DEVELOPMENT REVIEW BOARD REPORT

MEETING DATE: March 24, 2005

CASE NUMBER/ PROJECT NAME	10-DR-2005 Vista Del Camino		
LOCATION	7700 E Roosevelt Street		
REQUEST	Request approval of site plan and elevations for remodel, addition and modification to the Vista Del Camino Community Center.		
OWNER	City of Scottsdale 480-312-2367	ENGINEER	KPFF 602-264-1010
ARCHITECT/ DESIGNER	OWP/P Architects 602-294-6500	APPLICANT/ COORDINATOR	Bob Berg OWP/P Architects 602-636-6902

ELEVATIONS

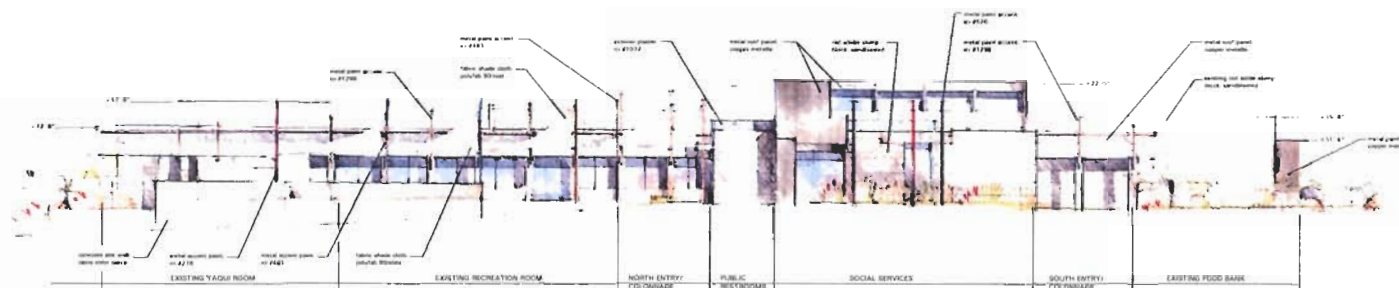
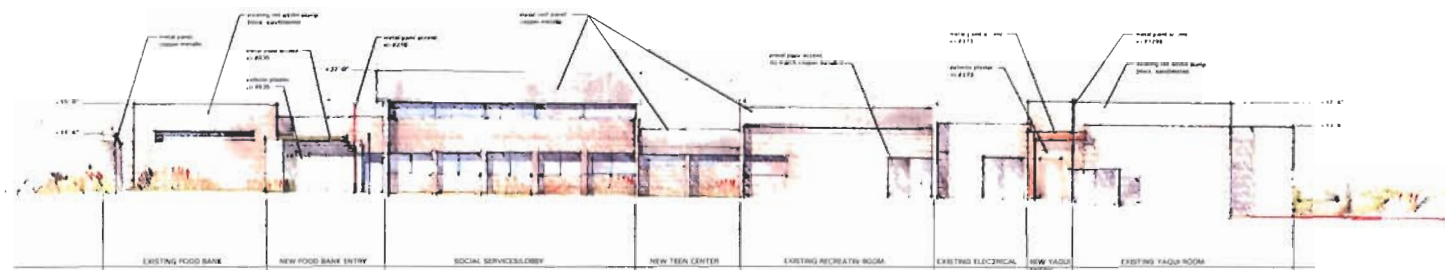
- a. Architectural elements, including dimensions, materials, form, color, and texture, shall be constructed to be consistent with the building elevations submitted by O'Donnell Wicklund Pigozzi and Peterson Inc. with a date provided on the plans by City of Scottsdale staff of 1/31/05.
